THE CITY OF NEW YORK  
OFFICE OF THE MAYOR  
NEW YORK, NY 10007

The City of New York ("the City") appreciates this opportunity to comment on the preliminary Draft Scope for the environmental review of Living Breakwaters and Tottenville Dune projects in Richmond County, New York.

**Project number:** GOVERNOR OFFICE STORM RECOVERY / 106-R  
**Project:** LIVING BREAKWATERS AND TOTTEVILLE DUNE PROJECTS  
**Date received:** 2/2/2015

**LIVING BREAKWATERS AND TOTTEVILLE DUNE PROJECTS**  
**Comments of NYC Department of Parks & Recreation (NYC DPR)**

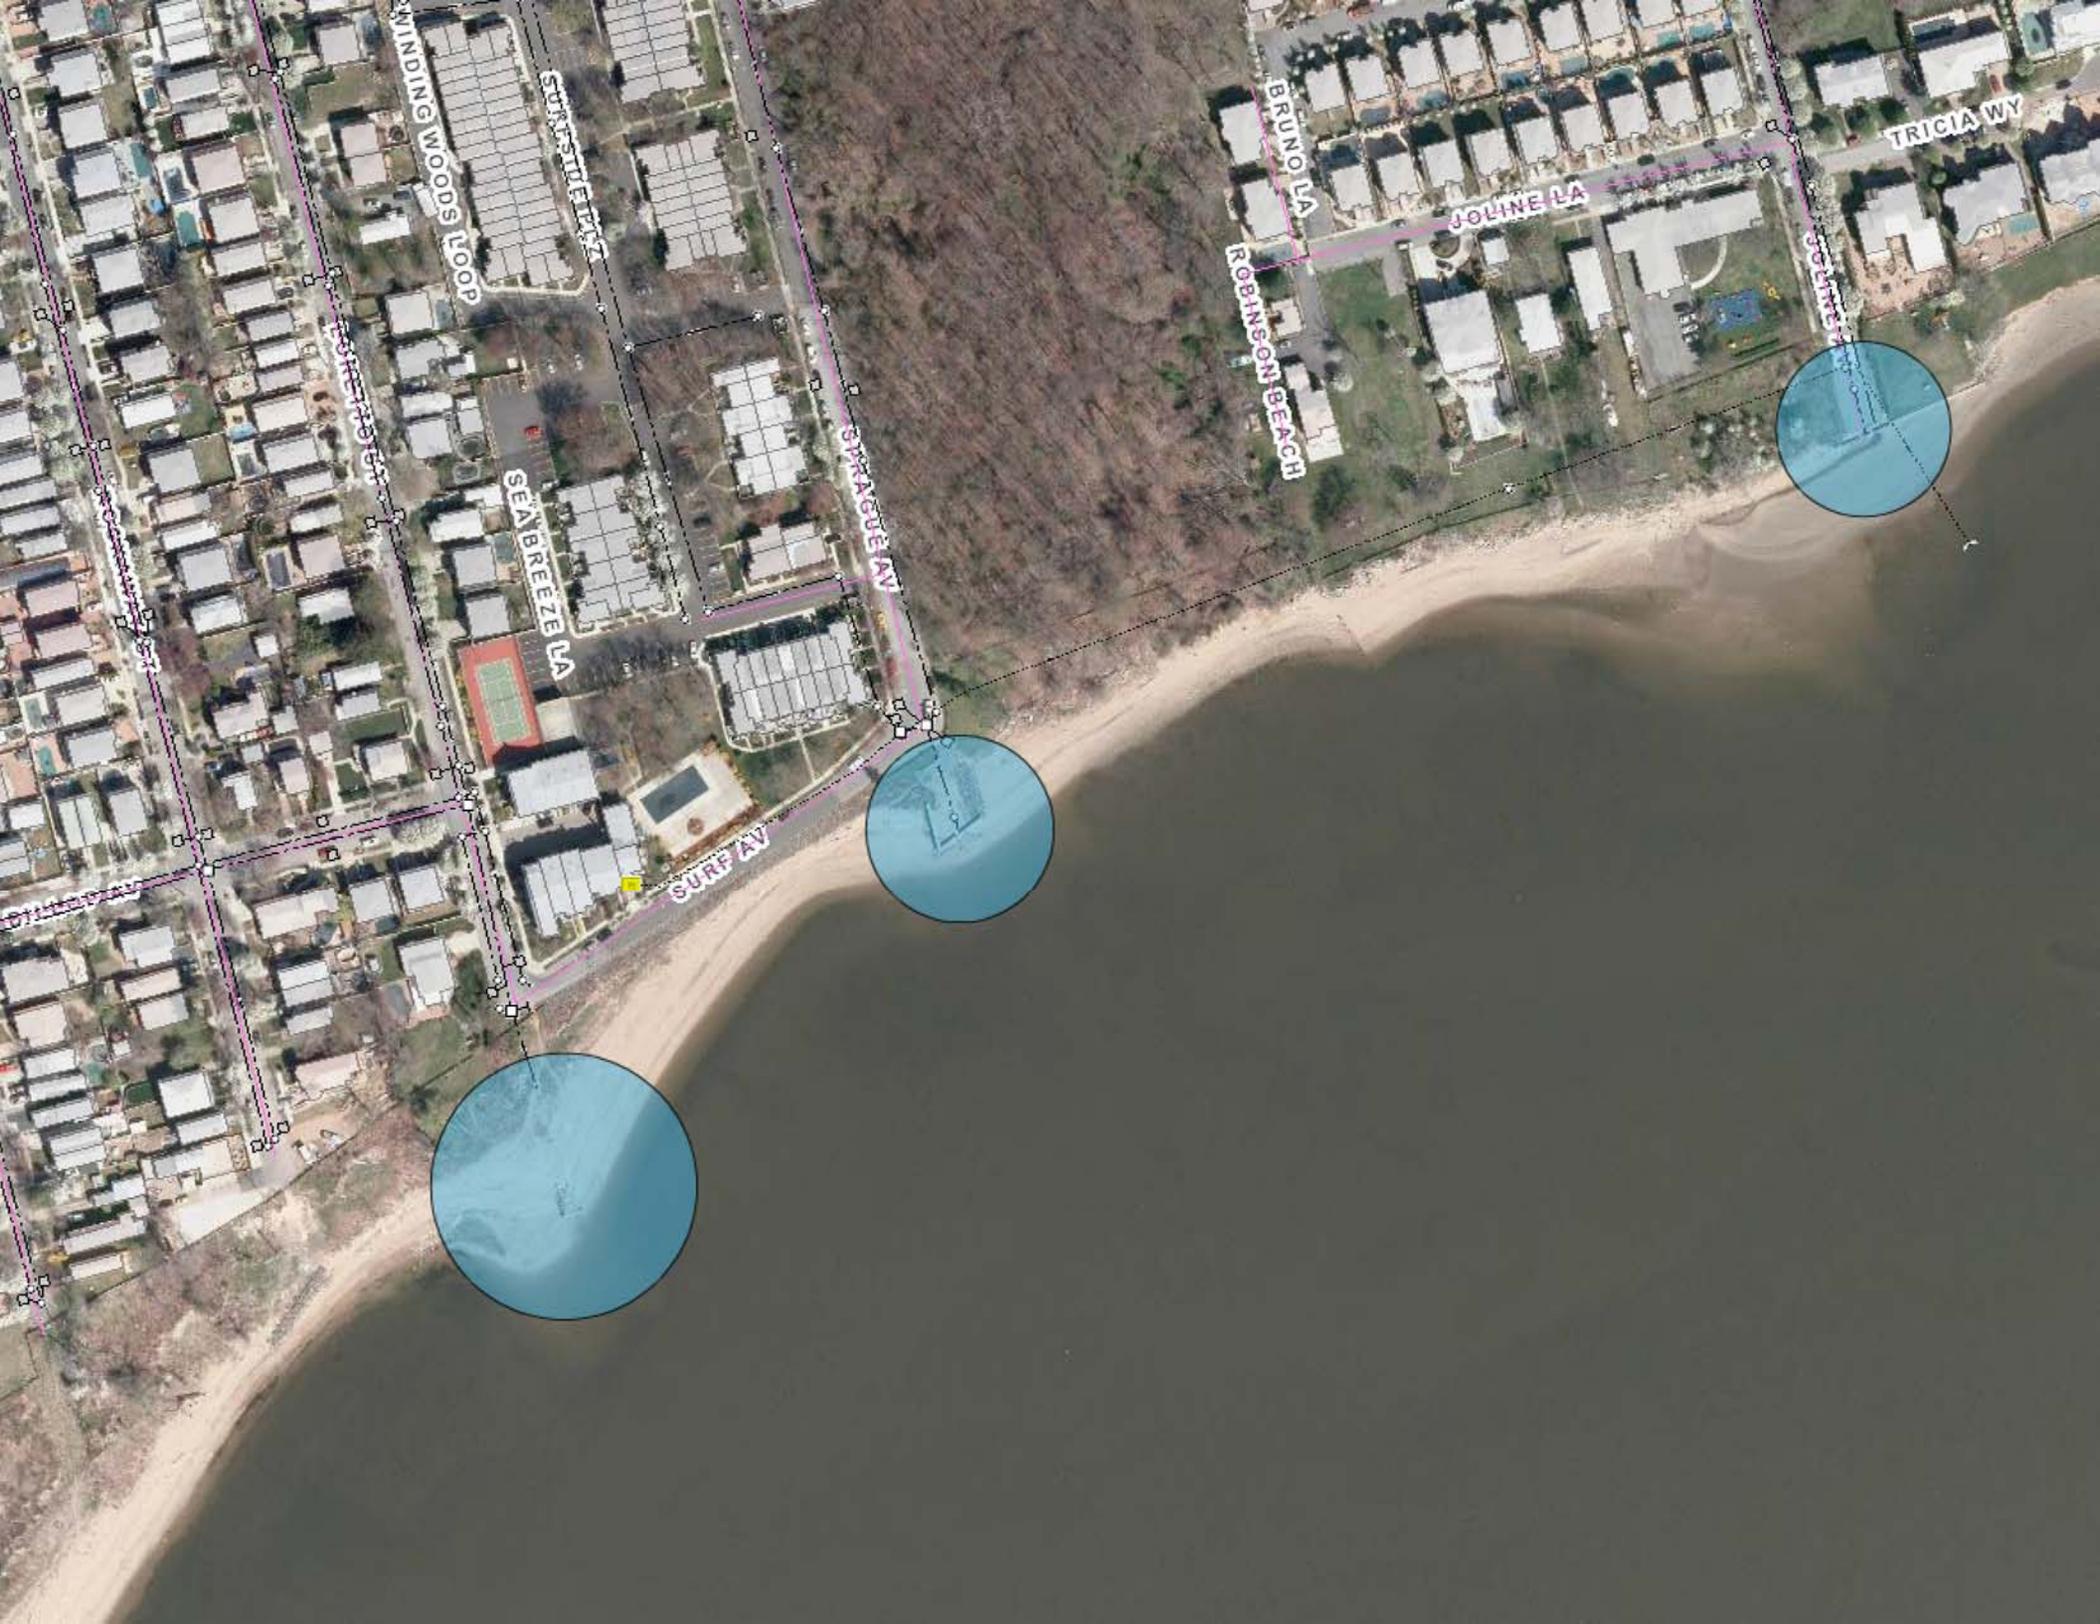
2. There are existing stormwater outfalls/outlets on Loretto street, Sprague Avenue, Joline Avenue, Bedell Avenue as well as natural drainage corridors which support BMPs in Conference House Park and near Cunningham Road and Richard Avenue, as well as Brighton and Manhattan Streets (see attached figure for image of some of the outfalls). The proposed dunes would front or be over some of these outlets, which do not extend far out into the water. How will the outfalls be incorporated into the berm designs? If the berm will be atop the storm pipes behind the headwalls, can the storm pipes handle the weight of the stone and sand atop them (since the pipes were likely not designed for the additional loading), or will improvements or reconstruction be necessary and whose responsibility would that be?
